RESPONSE TO COMMENTS

In accordance with the provisions of 40 Code of Federal Regulations (“C.F.R.”) §124.17, this document presents EPA’s responses to comments received on the following draft National Pollutant Discharge Elimination System (“NPDES”) permits:

Chelsea Sandwich Terminal (#MA0003280)
Global Petroleum Terminal (#MA0000825)
Gulf Oil Terminal (#MA0001091)
Irving Oil Terminal (#MA0001929)
Sunoco Logistics Terminal (#MA0004006)

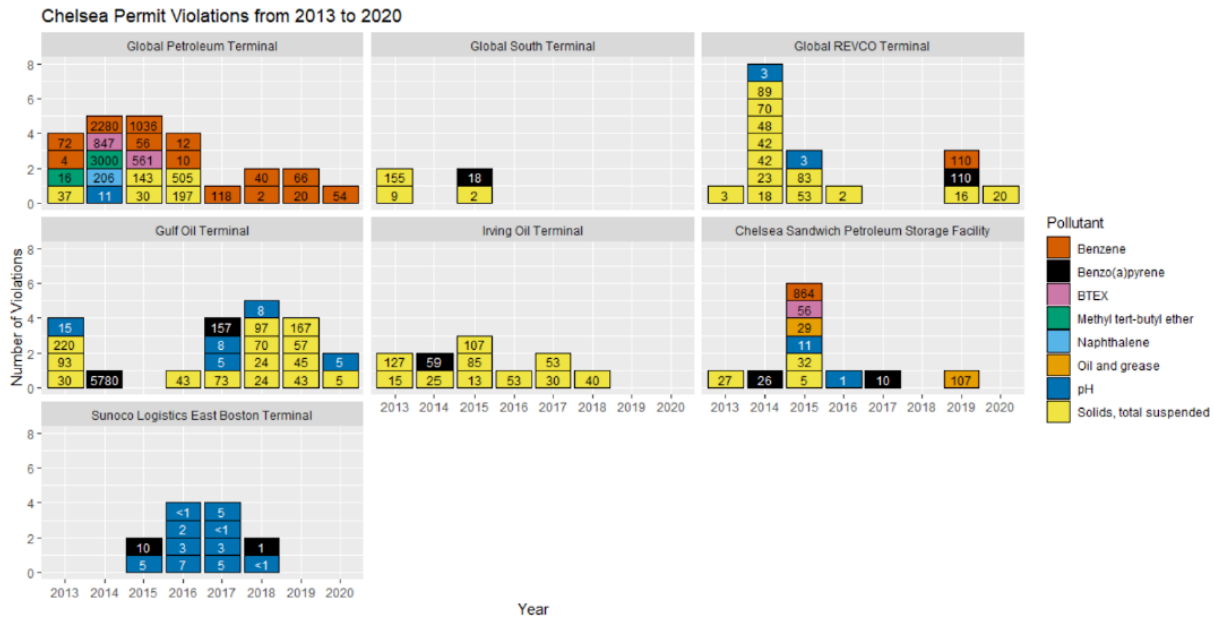
The oil storage facilities all have a history of violating their existing permits. The issue of noncompliance by these oil storage facilities first came to the authors' attention based on a collaborative research project, Chemicals in the Creek, when Dr. Wylie worked with GreenRoots to analyze effluent violations from the oil storage facilities between 2013 and 2017.⁴ This research culminated in a public art event where lanterns were released onto the Creek to remind viewers that these numbers represent tangible pollution, which in aggregate contribute to compromising the Creek. The facilities were invited to the event, and we held two follow up meetings to discuss historical non-compliance with them and how they might improve. We were hopeful that the public attention and positive interactions would lead to improved compliance. However, their record of 36 further violations since, belied that hope.

Since the beginning of 2017, there have been 36 further violations across the five companies. Particularly concerning are the recent benzene violations from Global Petroleum considering the fact that benzene is a carcinogen. Between 2013 and 2020, the seven facilities in Chelsea violated their permits at least 100 times collectively (Figure 1), not accounting for data gaps, which will be discussed later. All facilities have continued to violate their permits in the last five years. The most common violations are of total suspended solids (TSS). Global Petroleum facilities have been out of compliance at least once every year for benzene releases with a total of 13 violations for benzene. On two occasions, they exceeded their benzene limit by over 1000 percent. To summarize non-compliance issues, four of these seven facilities under permit review had at least one quarter of known noncompliance with CWA permits, and three of those were in noncompliance more often than in compliance (See Figure 1). This type of historic noncompliance must be considered in the re-permitting process in order to hold terminals accountable for consistent permit violations.

The consolidation of Global’s three facilities under one permit is especially concerning given they have had the majority of violations and specifically benzene violations (13 from Global Petroleum alone, as previously mentioned). Between these three facilities, there have been 14 benzene, 21 TSS, 2 methyl tert-butyl ether, 3 pH, 1 naphthalene, 2 benzo(a)pyrene, and 2 BTEX violations between 2013-2020 (see Figure 1). 45 out of the 100 violations occurred between the three Global facilities. When asked about the proposal to consolidate these permits into one, an EPA representative stated at the public meeting on March 15th, 2021 that this is based upon “administrative ease.”⁵ This is problematic reasoning since combining the facilities’ permits may make it harder to identify specific facilities’ permit exceedances. What measures will be taken to ensure that these facilities are held accountable for their violations after consolidation under one permit when violations have already gone unanswered as three separate permits?

Figure F.9. TRC concentrations at Global Outfalls from March 2015 through September 2021 based on Whole Effluent Toxicity Effluent Data

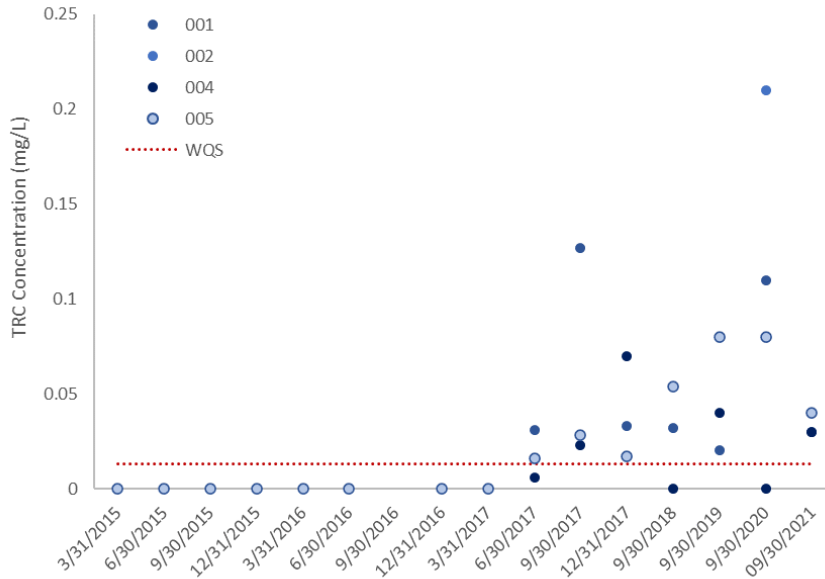
The comment asserts that limits should not be set where pollutants “have not been detected at a Facility” and further argues that “TRC is not actually present, used or stored at the Facility.” In fact, TRC was detected in whole effluent toxicity effluent samples at concentrations at or above the criterion at all four Facility outfalls multiple times during the last permit term (Fact Sheet Appendix A and Figure F.9 below). Sufficient evidence exists based on the detected values to find reasonable potential for discharges of chlorine at each of the four outfalls to cause or contribute to an exceedance of the acute TRC water quality standard.¹⁰³

In response to this comment and comment F.20, EPA verified reasonable potential for TRC by calculating a 95th percentile “upper bound” effluent concentration consistent with the statistical approach outlined in the *Technical Support Document for Water-quality Based Toxics Control* (TSD) (AR-114) and explained in Appendix C of the Fact Sheet. For this analysis EPA aggregated the effluent data over the Facility’s four outfalls,¹⁰⁴ based on the Permittee’s request in Comment F.18 “that for the same type of outfall within a Facility, the reasonable potential and effluent limits should be implemented facility-wide rather than applied separately for individual outfalls.” EPA understands how having the same parameters and limits applicable to all external outfalls would be less confusing for the Permittee. *See* Comment F.18. Furthermore, EPA agrees that the stormwater discharges are exposed to the same industrial processes and materials and receive identical treatment before discharge and, therefore, that it is reasonable to analyze reasonable potential and calculate limits facility wide in this case. *See* Comment F.27. Because EPA was recalculating the reasonable potential, EPA also updated the data through November 2021 so that the analysis reflected the most up-to-date conditions at the Facility. The analysis assumed no available dilution. *See* Response to Comment F.21. The 95th percentile effluent value based on a delta-lognormal distribution (appropriate for datasets with non-detect values) is 106 µg/L. Where there is not dilution, the projected downstream concentration is equal to the effluent concentration. *See* Response Comment F.20. The projected value is well above the 13 µg/L (0.013 mg/L) saltwater acute TRC criterion and demonstrate reasonable potential for the Facility’s discharges to cause or contribute to an exceedance of water quality standards.

According to the comment, the Facility “does not engage in activities that would be expected to generate significant sources of TRC.” EPA agrees that the source of TRC in the effluent is unclear. As the comment points out, TRC is not used in the industrial processes at the site. However, effluent data (as shown in Figure F.9) plainly show that TRC is present in the effluent and, in particular, indicate that TRC is consistently detected beginning in 2017. Potable water is one possible source of TRC in the effluent but, as the comment points out, hydrostatic testing (a known source of potable water) is infrequent and unlikely to cause the consistent, observed values. It is possible that operational changes introduced in 2017 (e.g., a change in use of potable water for washing down structures) may have resulted in the increase in detections.¹⁰⁵ At a minimum, EPA recommends that the Permittee complete a source identification program to investigate the likely sources of TRC to the effluent and implementation of operational controls or other BMPs to minimize discharges of TRC to ensure the protection of water quality. The identification and control of sources of pollutants, including TRC, is consistent with Part I.C.1.a. of the Final Permit (as proposed in the Draft Permit), which establishes BMPs to minimize pollutant discharges, including: good housekeeping measures, preventative maintenance, handling procedures for materials used for snow and ice control, and evaluation and elimination of unauthorized, non-stormwater discharges.
